WEST & EAST
 ELEVATION

DPD ZONING SUBMITTAL FOR PORTION OF BLOCK 3 OF MILWAUKEE BUCKS ARENA DEVELOPMENT - GPD

**THE PROPOSED VENUES ARE EXACTLY WHAT
THE CITY'S PLANNING HAS ATTEMPTED TO PREVENT**
(Highlighted provisions are quoted directly from current standards)

FIRST FLOOR TRANSPARENCY PLAN

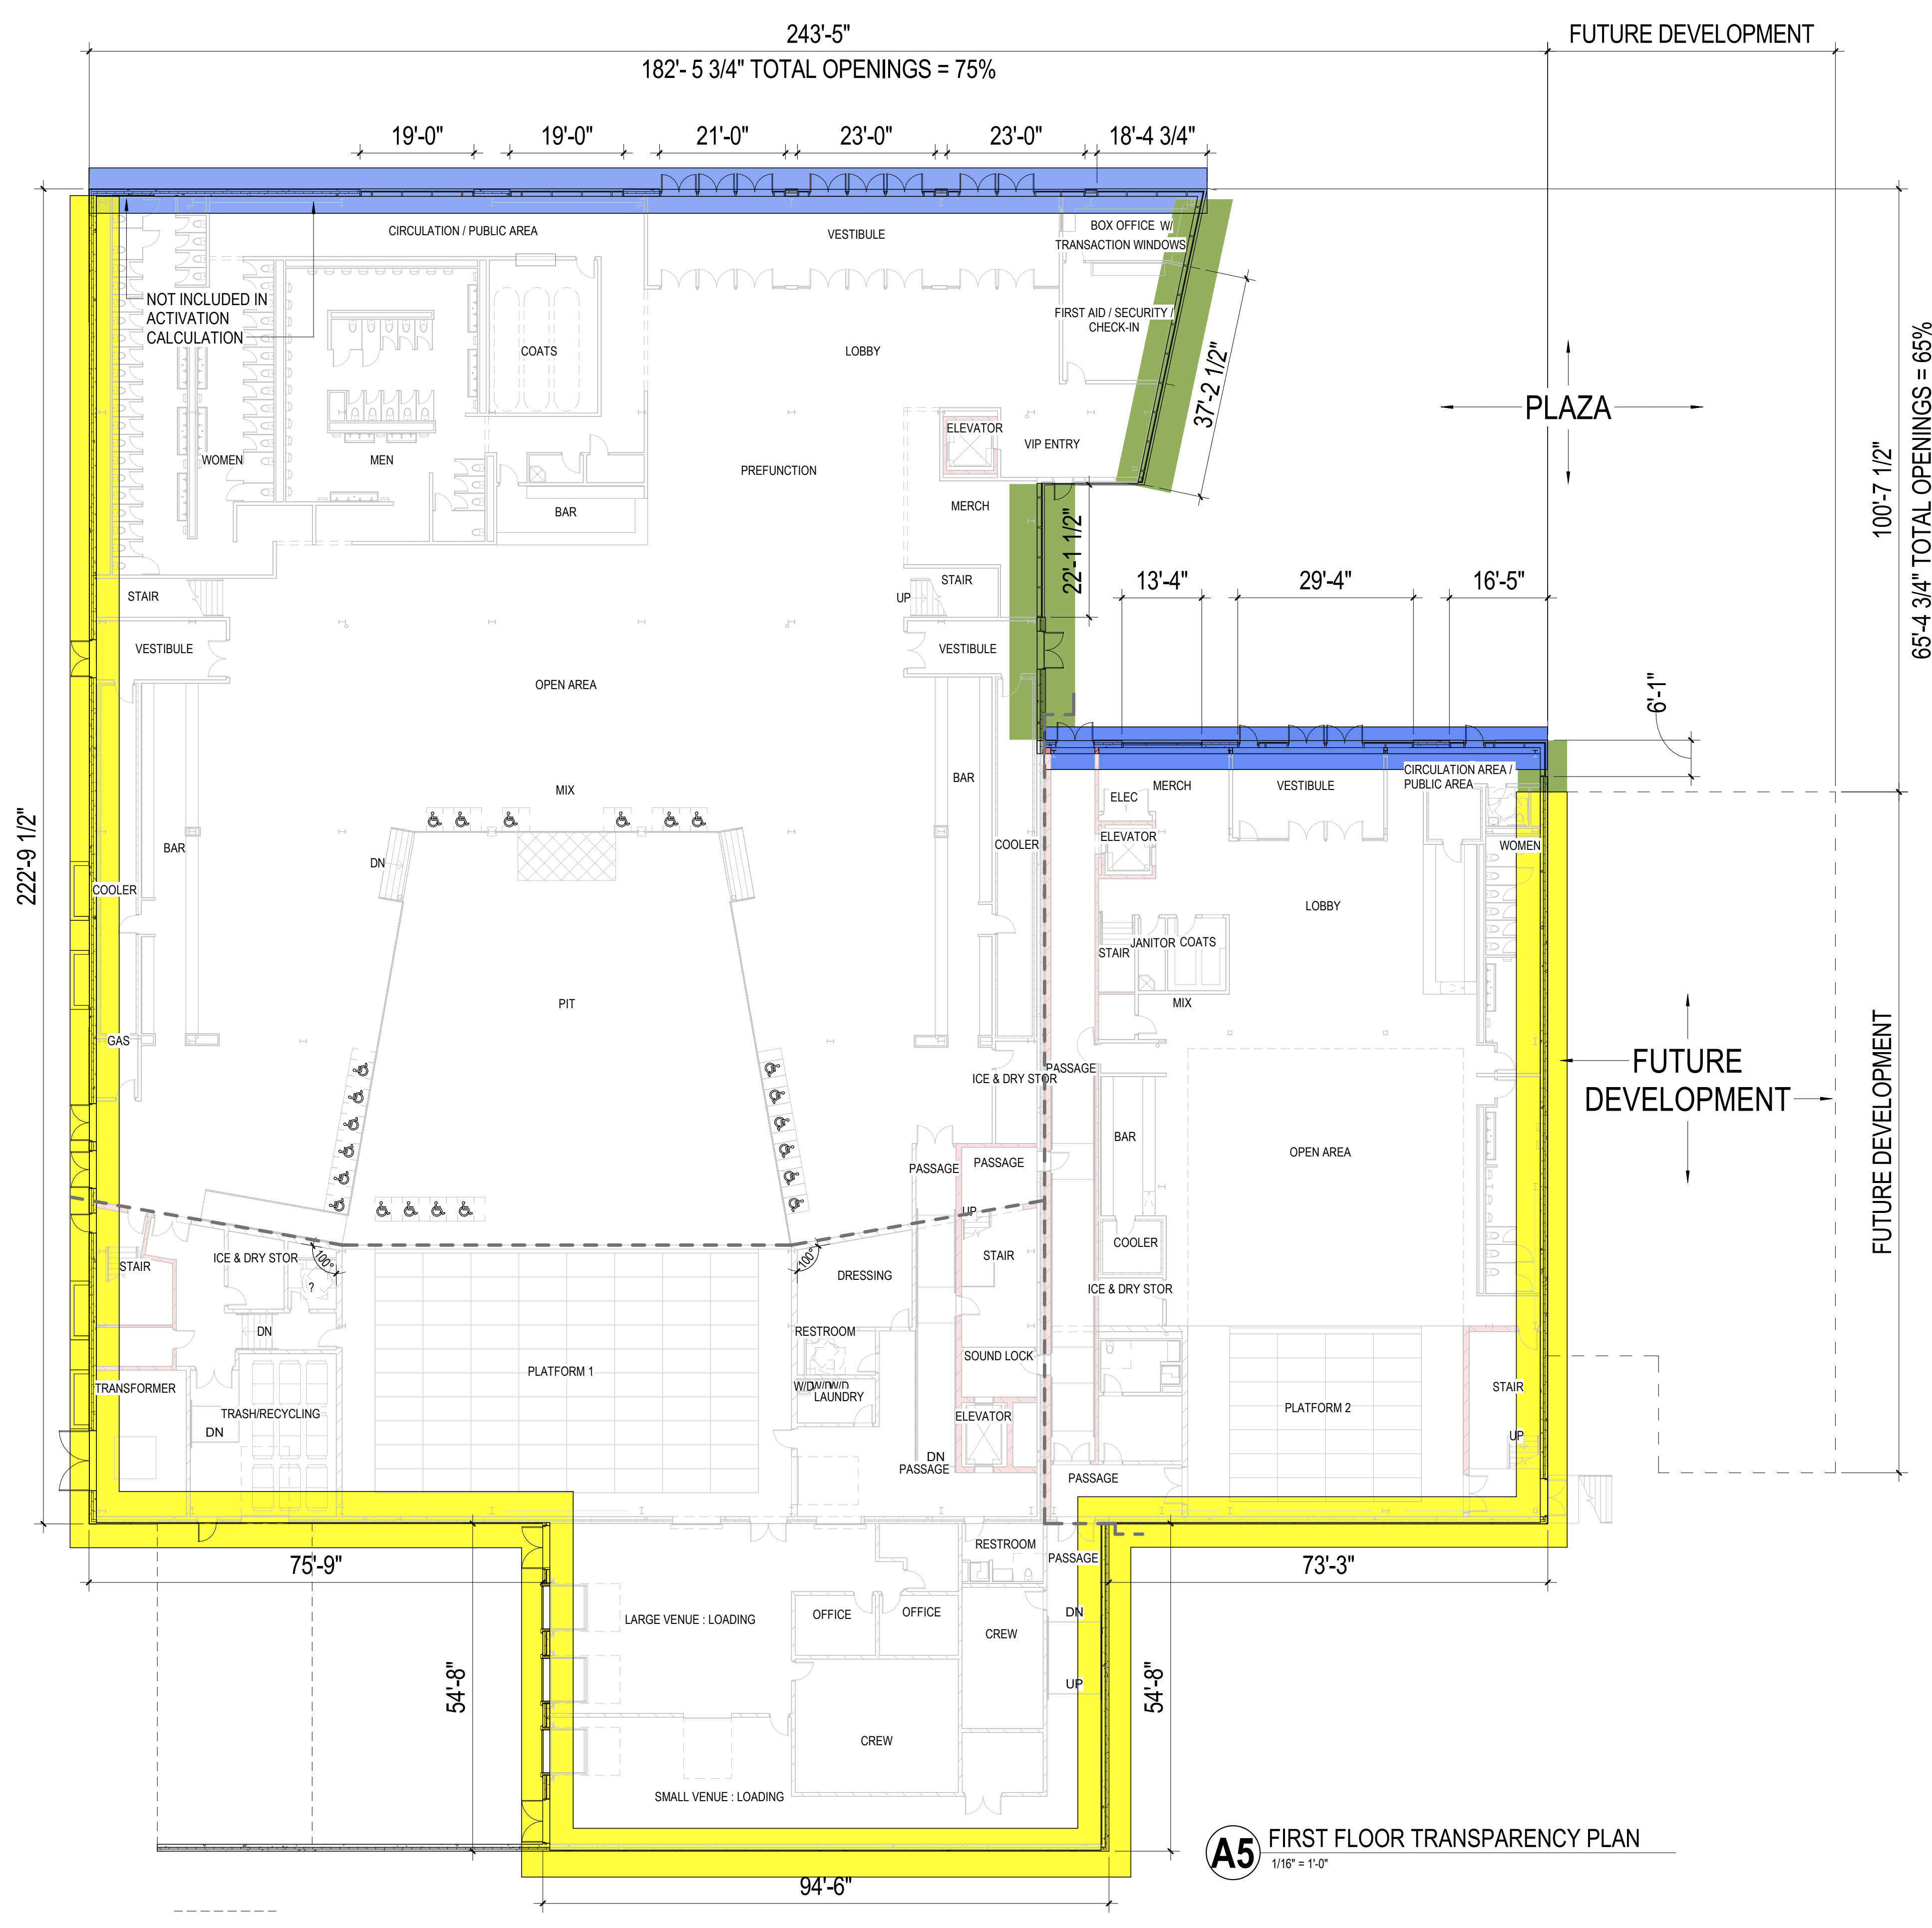
- The 48-foot setback, the lack of buildings fronting on James Lovell and the flat, windowless wall facing east are precisely what the city does not want. This proposal fails to meet the following goals and values of the GPD:
 - **Street Activation**
 - **Enrichment of the pedestrian realm**
 - **Human scale qualities**
 - **Horizontal and vertical modulation**
 - **Articulation**

- By moving the building back 48 feet, the developer is attempting to totally avoid the following requirements of the GPD. In the process, the nature of the neighborhood will be totally different than the urban, street activated plan of the city.
